**ADDENDUM NO. 2 TO DRAFT REMEDIAL ACTION WORK PLAN  
OPERABLE UNIT 3, POHATCONG VALLEY GROUNDWATER  
CONTAMINATION SUPERFUND SITE, WARREN COUNTY, NEW JERSEY**

November 14, 2019

Attachment 1 – Responses to USEPA Request for Clarifications Received by E-Mail Dated 11/4/2019

Attachment 2 - Addendum No. 2 to Draft Remedial Action Work Plan

FIGURE 7

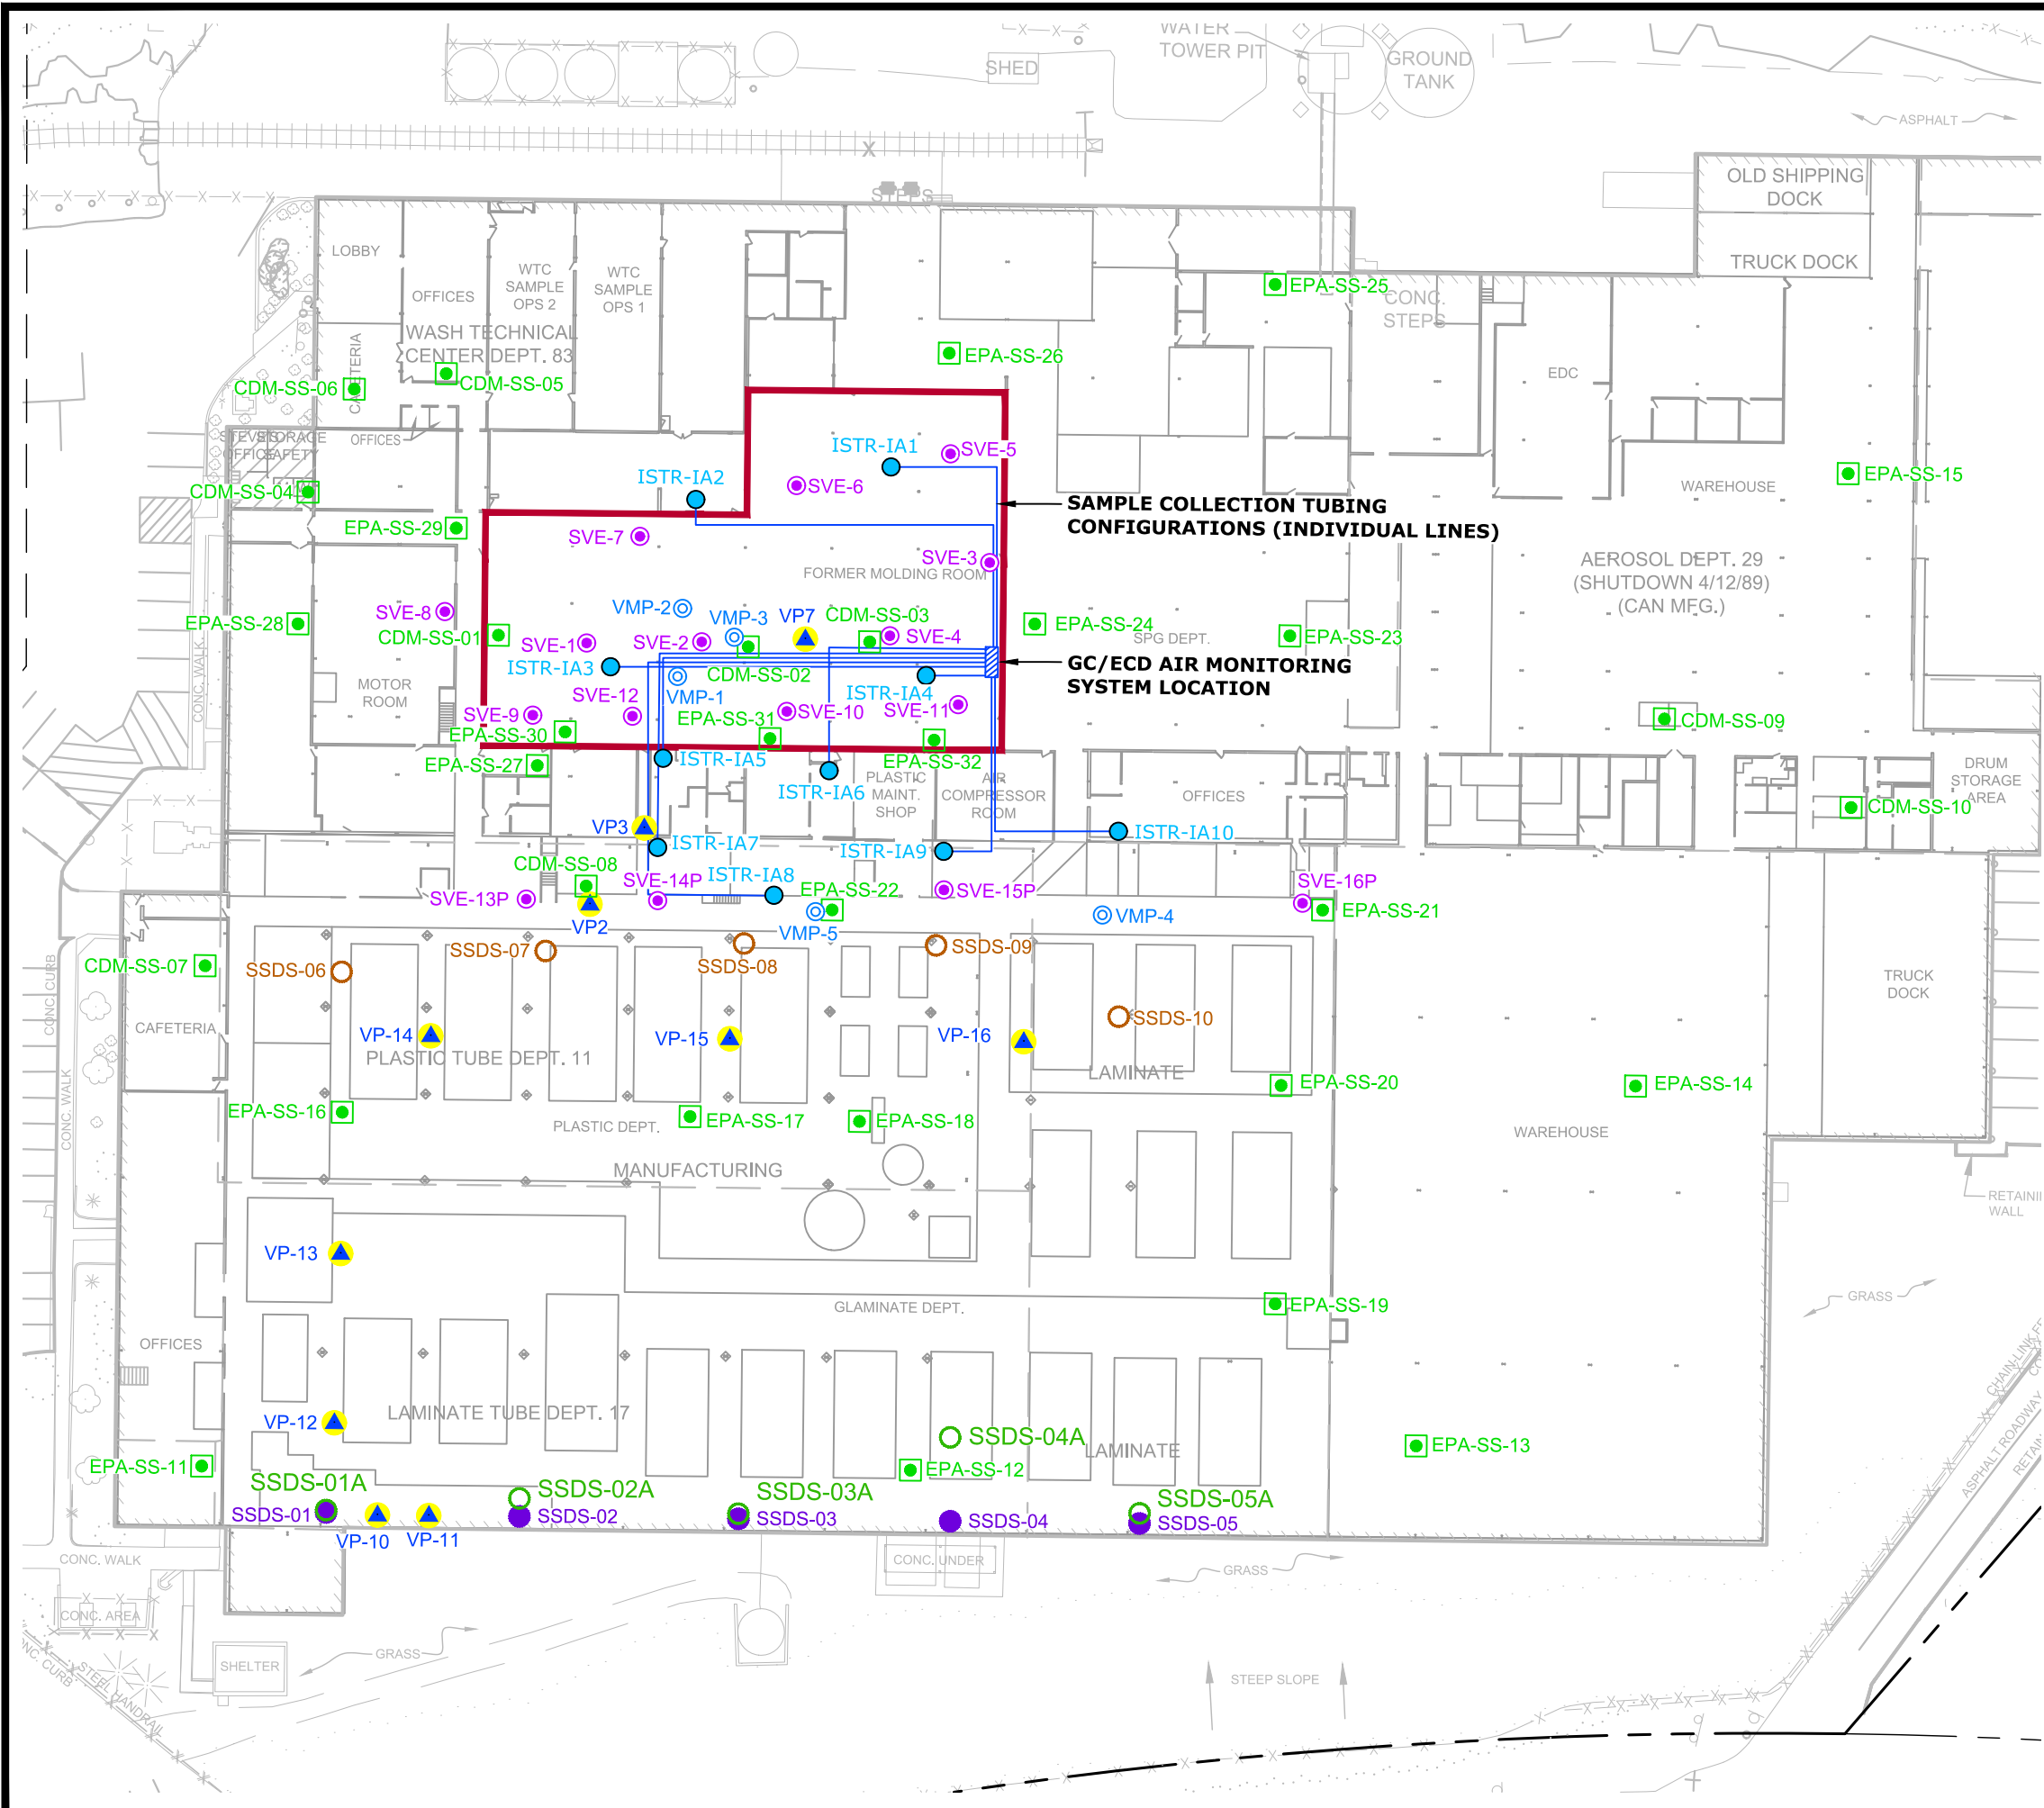
- Revised text to the Draft Remedial Action Work Plan Addendum No. 1 (Ramboll, October 2019) ("RAWP Addendum No. 1") in redline/strikeout format (to illustrate the proposed changes)
- Revised Figure7 (Indoor Air Monitoring Locations During ISTR) to the to the Draft RAWP
- Revisions to Draft RAWP Appendix A (Electrical Contractor Certifications)
- Revisions to Draft RAWP Appendix C (Traffic Management Plan)
- Revisions to Draft RAWP Appendix D (Field Sampling Plan)
- Revisions to Draft RAWP Appendix F (OM&M Plan)
- Revisions to RAWP Addendum No. 1 Appendix G (Health and Safety Plan)

Two (2) additional VMPs will be installed as part of the thermal remediation system installation. Three (3) VMPs were previously installed during the pre-design investigation activities. The existing VMPs (VMP-1, VMP-2 and VMP-3) are located within the Group C heaters in the FMR. The additional VMPs will be installed within the Group A heaters (VMP-4) and Group B heaters (VMP-5) within the MPA. VMP-5 will be collocated with temperature monitoring point T-14. The two additional VMPs will be installed at the locations shown on Figure 7.

FIGURE  
**D-4**

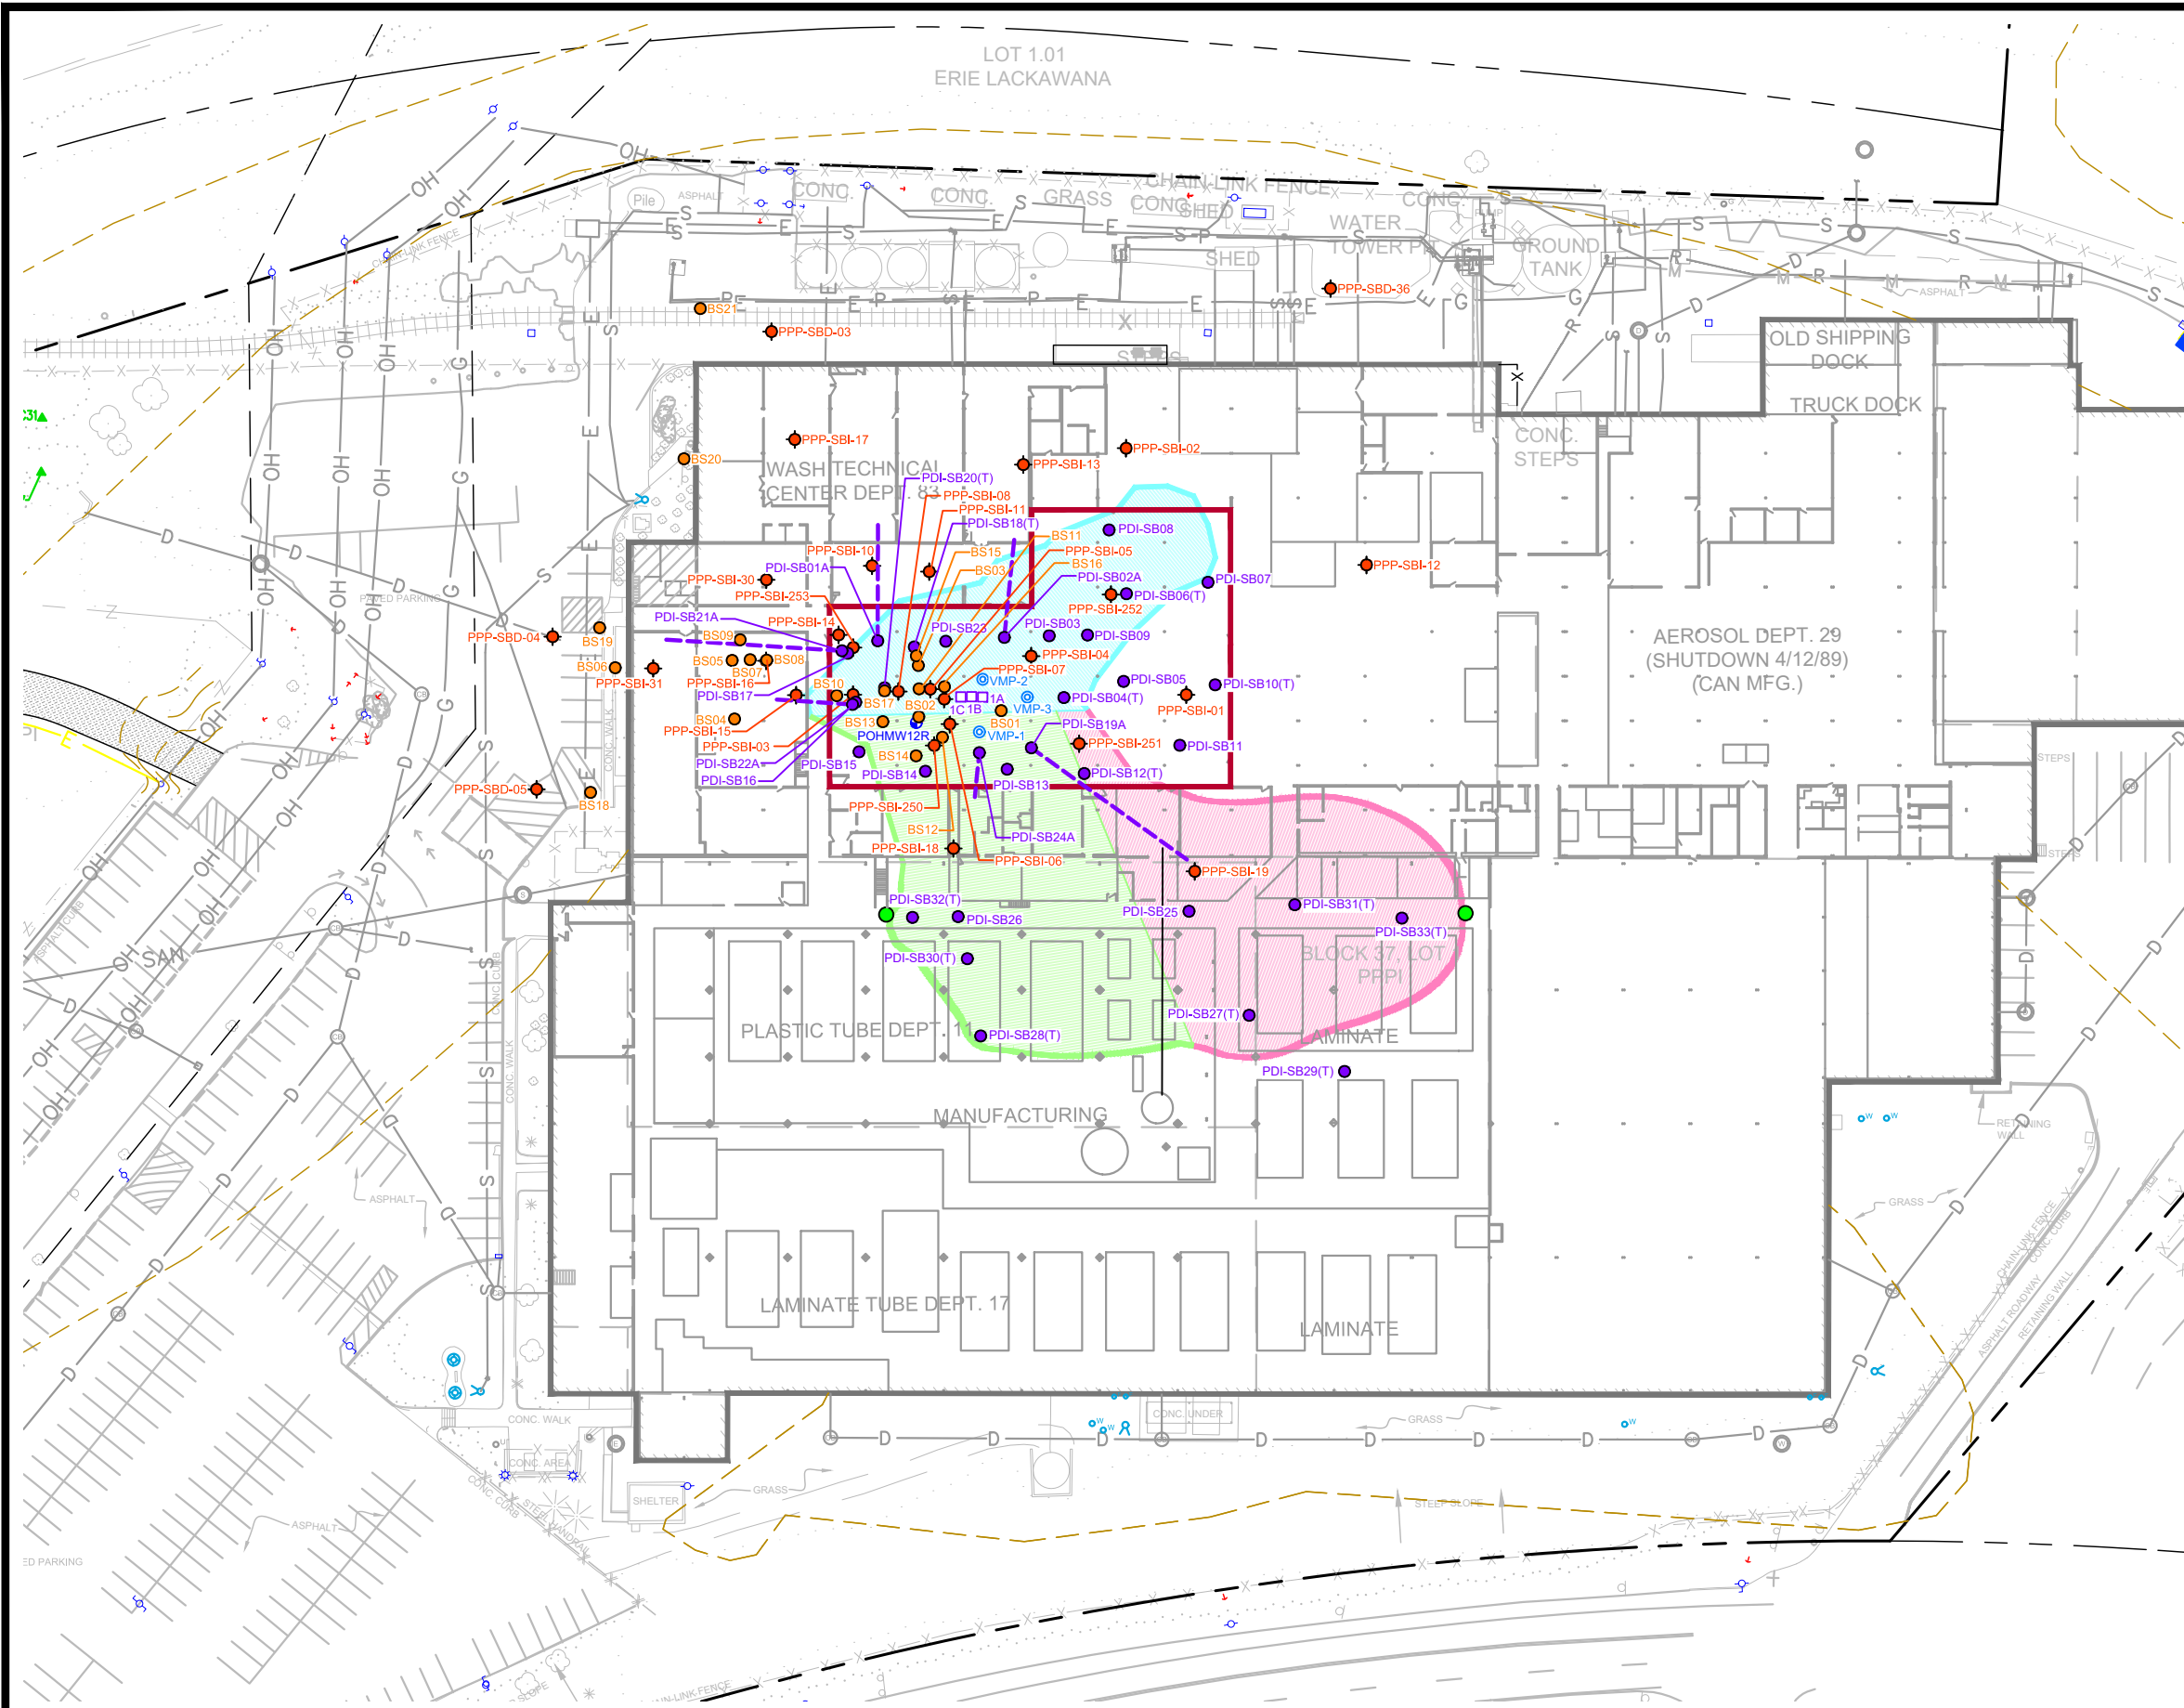
If post-remediation soil sampling is requested by the USEPA, up to ~~three~~ two soil borings will be installed within each of the three heater Groups (Group A, Group B and Group C) for a total of up to six post-remediation soil borings. Draft locations (which may be adjusted in the field) for post-remediation soil sample borings are shown on Figure D-4. For the post-remediation soil sampling performed within the area of the Group A and Group B heaters (if needed), borings are proposed be installed when access can be secured during a planned facility shutdown in the Main Production Area operations. For the post-remediation soil sampling performed within the area of the Group C heaters (if needed), borings will be located within the 10-foot wide access corridor located within the Former Molding Room Area~~at the approximate locations depicted on Figure D-3~~. Each post-remediation soil boring depicted on Figure D-~~34~~ will be installed vertically (90° angle from horizontal) and drilled to the base of the target treatment zone (TTZ) (approximately 120 feet bgs) or until competent bedrock is reached, whichever is shallowest.
